RESPONSE TO REQUEST FOR COMMENTS

CASE/APP NUMBER: SPR-ADJ-DAP-DR22-24

PROPERTY LOCATION: 5205 Battle Creek Rd SE, Salem OR 97306

COMMENTS FROM: Jolynn Franke, Transit Planner I, Cherriots

Approximate transit stop locations requested:

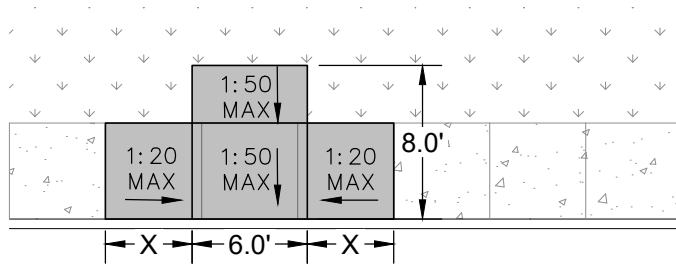
COMMENTS: Transit stops have been identified as needed in connection with this proposed development. Cherriots requests two transit stops conforming to the applicable standards of the Salem Area Mass Transit District to be constructed and right-of-way dedication, if necessary, to be provided as part of the street improvements for this development. On-street parking shall be restricted in the areas of the transit stops in order to ensure unobstructed access by transit. The transit stops should be located on Battle Creek Rd SE at the intersection with Eastlake Dr SE, far-side of the pedestrian crossing in both directions. Approximate locations are marked in the screenshot on the following page. The southbound stop should be a minimum of 50 feet away from the crosswalk. Cherriots recommends extending the curb bulb design depicted in the drawings to match the length of the median in order to accommodate the stop. The northbound stop should be a minimum of 50 feet away from the Eastlake Dr SE intersection (measured from the tangent of the intersecting street). Per our conversation with Public Works, bus pullouts are not requested for these stops. Also included in the following pages are Cherriots standard bus stop and no-parking zone design drawings.
